September 19, 2017

Re: Northwest Training and Testing Supplemental Environmental Impact Statement/Overseas Environmental Impact Statement (EIS/OEIS)

RE: Draft Environmental Impact Statement for the additional Growler Aircraft on Whidbey Island.

Re: Objection Pacific Northwest Electronic Warfare Range (EWR)
More Specifically Re: The Draft Decision Notice and Finding of No Significant Impact (DN/FONSI) issued on November 29, 2016, by the Responsible Official, Dean Millet, the District Ranger of the Pacific Ranger District of the Olympic National Forest, which is the affected National Forest

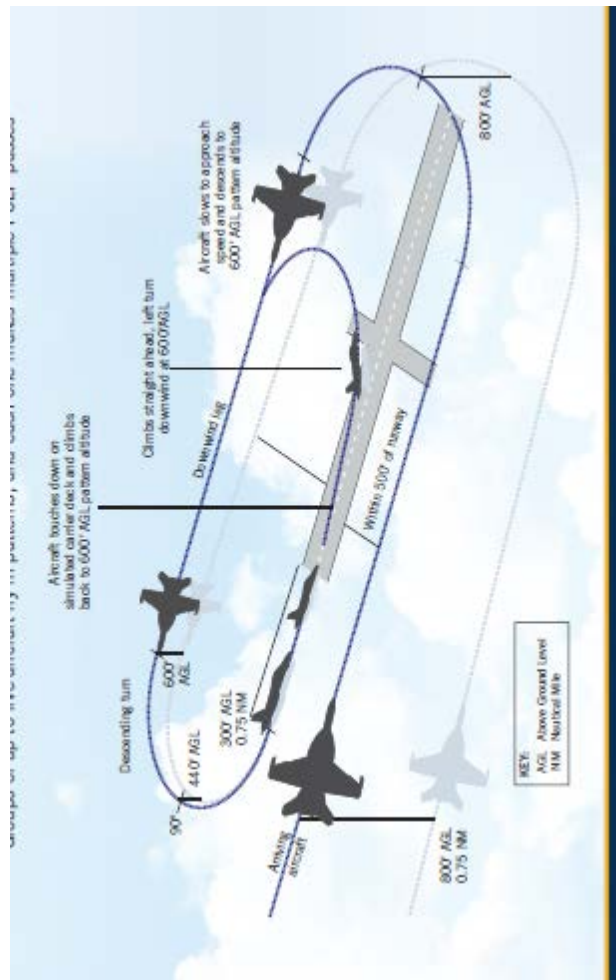
The geographic area proposed to be covered by the EIS is limited to the Whidbey Island area generally, and to landings, takeoffs, and touch and go training at Ault and OLF fields. In this regard, a diagram on the left side of the "Growler Operations" page of the Scoping Meeting Guide is most telling. That diagram includes three flight paths that extend to the southwest of the area shown as follows:

Those flight paths, we are sure, lead to the Navy's proposed Pacific Northwest Electronic Warfare Range (EWR). The impacts of the Growlers on those flight paths do not end at the boundaries of the Navy's diagram. The impacts extend as far as the Growlers fly.

Under NEPA those impacts must be evaluated in the EIS – both in the area between Whidbey Island and the proposed EWR, and in the area of the proposed EWR. Because that was not done in the Navy's Environmental Assessment (EA) for the proposed EWR, it should be done now. This is also necessary under the 1988 Master Agreement between the Department of Defense and the US Department of Agriculture. That Master Agreement requires the Forest Service to study both the impacts of the proposed land-based training activities and the impacts of the proposed use of airspace if “directly associated with the land based training.”
